**From:** [Opel, Laura \(MMO\)](#)  
**To:** [Hornsea Project Three](#)  
**Cc:** [West, Richard \(MMO\)](#); [Stephenson, Paul \(MMO\)](#)  
**Subject:** EN010080 - Hornsea Project 3 Deadline 3 submission  
**Date:** 14 December 2018 12:22:06  
**Attachments:** [EN010080 - Annex A - MMO guidance on MCZ assessments.pdf](#)  
[EN010080 - Annex B - MMO comments on In Principle Monitoring Plan.pdf](#)  
[EN010080 - Annex C - MMO comments on Herring Noise Contours.pdf](#)  
[EN010080 - Example MMO MCZ screening document.pdf](#)  
[EN010080 - Example MMO MCZ Stage 1 Assessment.pdf](#)  
[EN010080 - Hornsea Project Three - Deadline 3 - MMO Post Hearing Submission.pdf](#)

MMO Reference: DCO/2016/00001  
Planning Inspectorate Reference: EN010080

## Annex C

### Planning Act 2008, Orsted Hornsea Project Three Limited, Proposed Hornsea Project Three Offshore Windfarm Order – Concurrent Piling

**A: Additional Herring Noise contours as submitted by the Applicant on the 3<sup>rd</sup> December 2018 via email.**

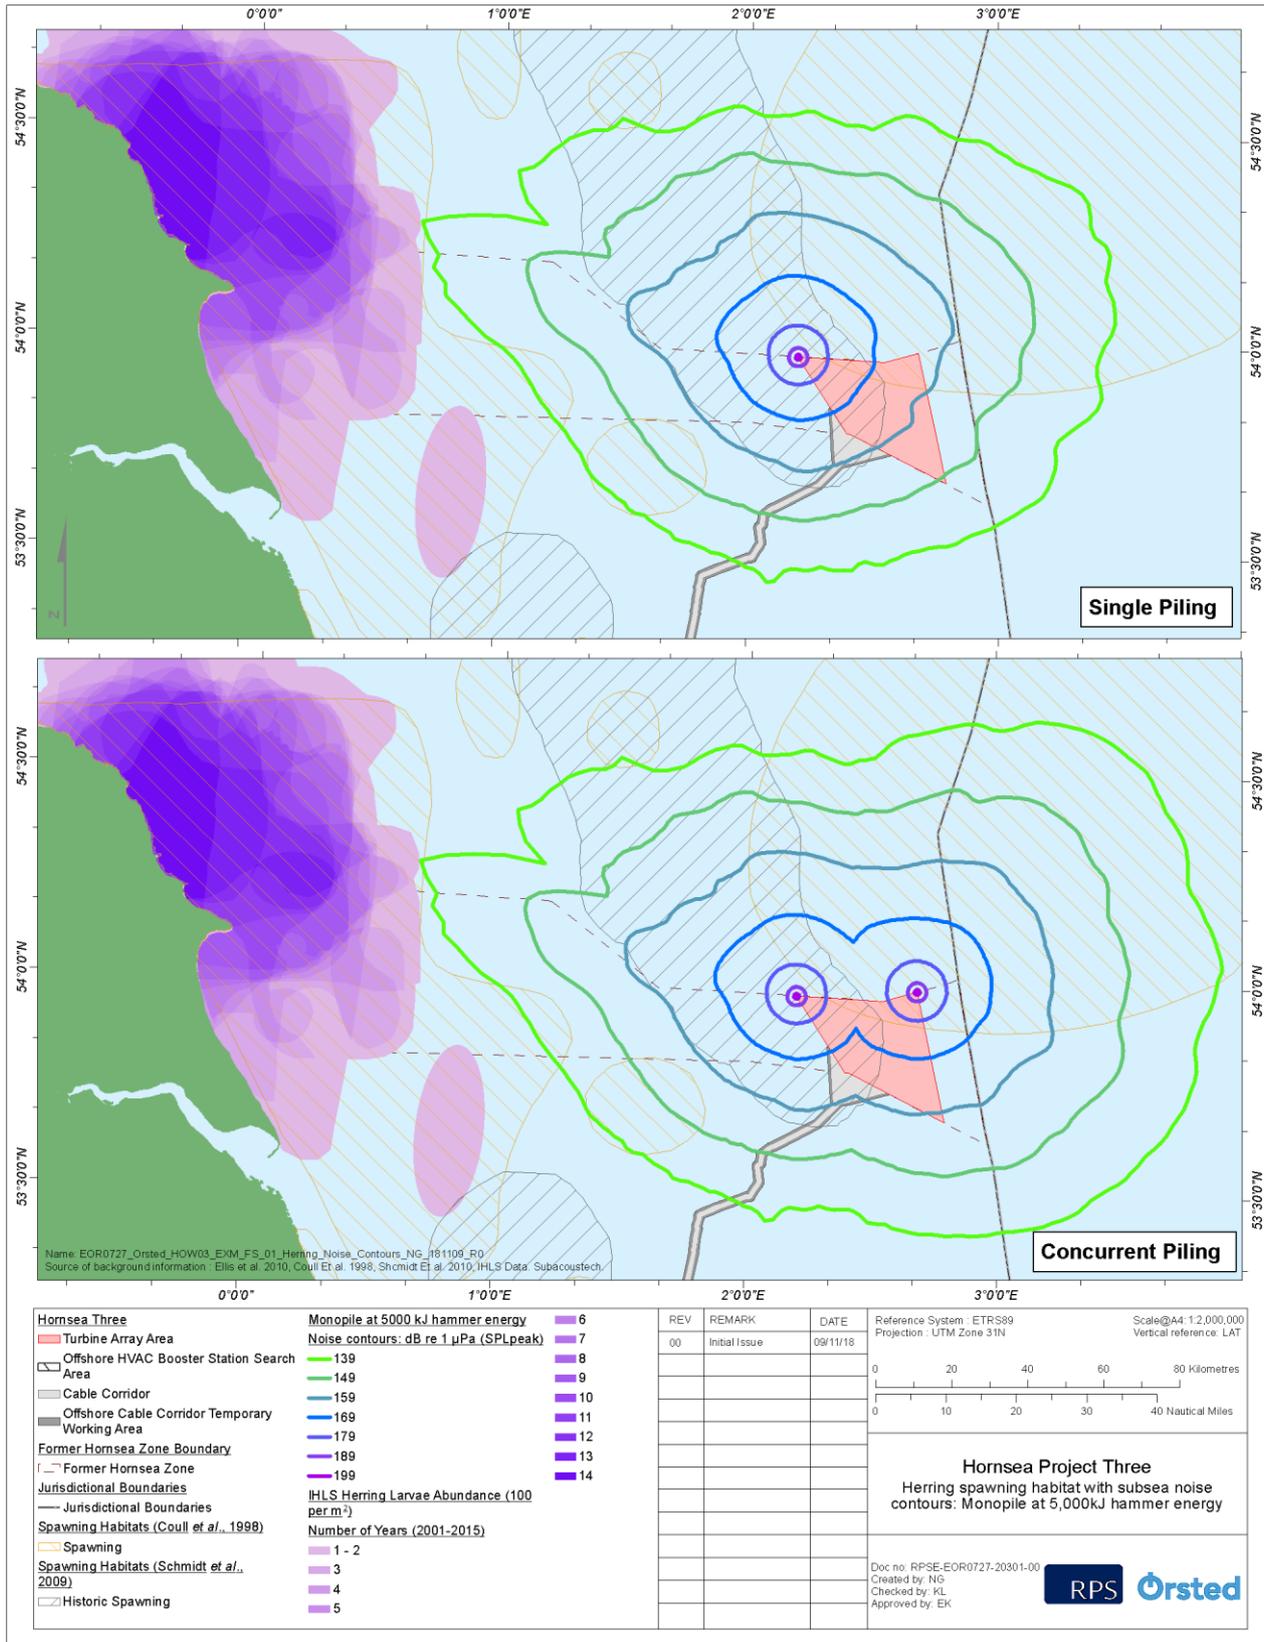
1. The MMO appreciate that Ørsted have provided updated modelling in relation to concurrent piling. Updated modelling is for a single pile and concurrent piling, showing the SPL<sub>peak</sub> noise contours based on a 5,000 kJ hammer energy. Using noise exposure criteria from Popper et al. (2014), the risk of mortality, potential mortal injury and recoverable injury at the onset of piling are likely only at close ranges to the source (relevant threshold for fish with swim bladder involved in hearing is > 207dB peak).

2. The MMO note that the applicant has provided the SPL<sub>peak</sub> contours based on concurrent piling in their response. As requested, they have included a Figure (under point A) showing the indicative noise contours, with a second noise contour within the array. The response states that:  
*“At a great distance from piling activities the pulses (the SPL<sub>peak</sub> contours are for a single pulse) from two sources are highly unlikely to occur at the same time at any one location – consecutive pulses travelling through the water will be 3 km apart or more. In the worst case scenario, whereby two piles are installed adjacent to one another and*

*these pulses combine, this will cause a maximum 3 dB increase in the noise level, leading to 142 dB SPL<sub>peak</sub> at the edge of Flamborough Head spawning ground, rather than 139dB as shown in Figure 3.4 of the Fish and Shellfish ES chapter and attached). This is assuming the absolute maximum hammer energy at the location closest to the spawning ground (i.e. the most conservative assumptions”.*

The MMO would also expect to see the modelled results (for injury and Temporary Threshold Shift, TTS) based on the cumulative Sound Exposure Level (SEL<sub>cum</sub>) for a stationary fish receptor.

4. Nevertheless, the Applicant has provided an additional run of noise modelling assuming a non-fleeing fish at the eastern edge of Flamborough Head spawning ground (i.e. closest to the Hornsea Three array area). The scenario assumes concurrent piling in the western corner of the array area and 5,000 kJ hammer energy. The modelling concluded that the received levels would be approximately 171 dB SEL<sub>cum</sub>; this is approximately 15 dB lower than the TTS criteria stated in Popper et al. (2014). In order to provide more clarity on the above, the MMO would like to see the modelled received levels for SEL<sub>cum</sub>, as has been done for the peak SPL (showing the spawning habitats).

5. Additionally, the MMO recommend that the hammer energy profiles for the SEL<sub>cum</sub> scenarios should also be provided (including the number of piles installed in 24 hours, number of strikes, source level etc.). Volume 4 – 3.1 Subsea Noise Technical Report includes Figures 5.3 to 5.10 showing the unweighted single strike SEL (SEL<sub>ss</sub>) noise levels. The MMO consider that it would be appropriate to show similar figures for concurrent piling based on a 5,000 kJ hammer energy.

We discussed at that time, showing the updated indicative noise contours associated with piling in the Hornsea Three array area relative to the Flamborough Head spawning ground (as shown in Figure 3.4 of the Fish and Shellfish ES chapter), but assuming concurrent piling. We explained that due to the metric used (i.e. SPL<sub>peak</sub>), addition of a second piling location would extend these contours to the east (i.e. any further piling locations would be east of the most westerly corner of the array area), and would not increase the risk of behavioural effects on spawning adult herring, i.e. by extending the contours west into the spawning ground. As promised, we have produced a map showing a second noise contour within the array area (attached) and while it shows that the overall area of the combined contours is greater, these do not extend further east into the spawning ground. However, while we have presented these contours to you, you will see our Deadline 2 response on this point is a little different. The reason for this is that presentation of these contours is somewhat of a simplification of the situation.

At a great distance from piling activities the pulses (the SPL<sub>peak</sub> contours are for a single pulse) from two sources are highly unlikely to occur at the same time at any one location – consecutive pulses travelling through the water will be 3 km apart or more. In the worst

case scenario, whereby two piles are installed adjacent to one another and these pulses combine, this will cause a maximum 3 dB increase in the noise level, leading to 142 dB SPL<sub>peak</sub> at the edge of Flamborough Head spawning ground, rather than 139dB as shown in Figure 3.4 of the Fish and Shellfish ES chapter and attached). This is assuming the absolute maximum hammer energy at the location closest to the spawning ground (i.e. the most conservative assumptions).

While there are no agreed numerical behavioural avoidance criteria for fish, a noise level of under 140 dB SPL<sub>peak</sub> (<130 dB SEL<sub>ss</sub>) is of the order of background noise, and highly unlikely to produce any aversive reaction, especially due to the spreading of sound over large distances, reducing the potential for any startle reaction. This is in line with the results from Doksæter et al. (2012) – these levels are considerably below any level that produced an aversive reaction in that study.

Noting the concerns raised by the MMO, an additional run of the noise modelling has been undertaken assuming a non-fleeing fish (i.e. stationary receptor) at the eastern edge Flamborough Head spawning ground (i.e. closest to the Hornsea Three array area). This highly conservative scenario assumes:

- The absolute maximum hammer energy of 5,000 kJ;
- Concurrent piling in the western corner of the array area; and
- A stationary (non-fleeing) receptor at the edge of the Flamborough Head spawning ground.

This modelling run concluded that the noise levels associated with the entire duration of two concurrent pile installations would result in received levels of approximately 171 dB SEL<sub>cum</sub>. This is approximately 15 dB lower than the TTS criteria stated in Popper et al. (2014) even in this highly conservative, entirely hypothetical scenario.
